Office Action Summary	Application No. 10/080,933	Applicant(s) ZHANG ET AL.
	Examiner Jean B. Corrielus	Art Unit 2611

DETAILED ACTION

Zangi's Fig. 3

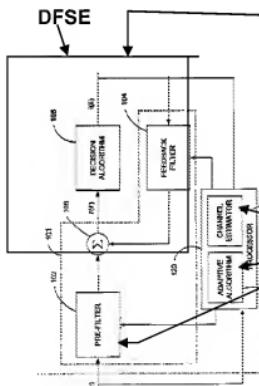
Applicant further submits that Zangi fails to disclose or suggest each and every element recited in claims 21 and 38. Specifically, Zangi fails to disclose or suggest, at least, "a decision feedback sequence estimator configured to receive the generated optimized values, wherein the decision feedback sequence estimator comprises a summing element, a feedback filter, and a maximum likelihood sequence estimator," as recited in claim 21 (emphasis added), and similarly recited in claim 38. However it is noted that such point of arguments have been previously presented by applicant in the response filed on 11/19/08 and rebutted by the examiner in the office action mailed on 12/19/08. Please refer to said office action for the examiner's rebuttal. In addition examiner maintains that at least Fig. 3 of Zangi shows the corresponding claim features of applicant's invention. As shown in the diagram below, each of applicant's claimed feature, shown, for instance in fig. 2, corresponds one to one to each of Zangi's components shown at least in fig. 3. The DFSE circuit of Zangi (see diagram below) , corresponding to applicant's claimed

limitation "DFSE", includes a summer 106, a feedback filter 104 and a maximum likelihood sequence estimator 108. in addition, the adaptive algorithm 124 of zangi corresponds to signal optimizer, shown in applicant's fig. 2, as block 74. Zangi further teaches a channel estimator 122, shown in applicant's fig. 2 as 54. Zangi teaches a prefilter 102 corresponding to applicant's circuit block 56 depicted in fig. 2. Since Zangi teaches every feature of the claimed invention, i.e., structurally and functionnaly, as depicted in the above rejection, and further, as shown in the mapping below, zangi anticipates the claimed invention.
